SB Number:	SB 2HS-005	Creation Date: 04/08/2009
Subject:	<i>Paper jam at the registration sensor can not be cleared</i>	
Model:	FS-1100/1300D/1350DN

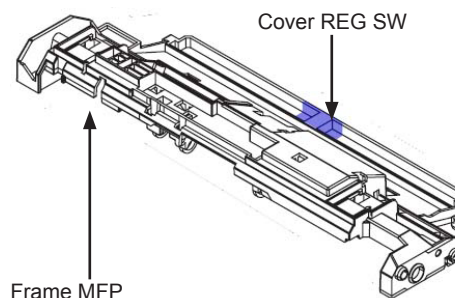
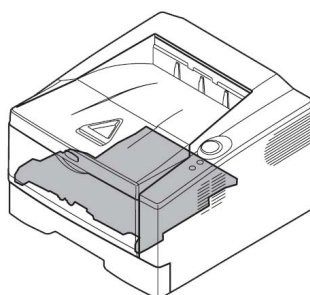
Phenomenon	A paper jam at the registration sensor is not cleared after removing the paper.
-------------------	---

Cause	A piece of paper is torn off and is trapped at the frame MFP 302HS08010.
--------------	--

Solution	<p>The following changes have been made:</p> <ol style="list-style-type: none"> 1. Cover reg SW 302HS08340 has been added to the frame MFP. 2. Spring pressure of spring cover REG 302HS08351 has been changed from 3 GF to 24 GF. 3. Based on the above mentioned change, the shape of the frame MFP 302HS08011 has been changed.
-----------------	---
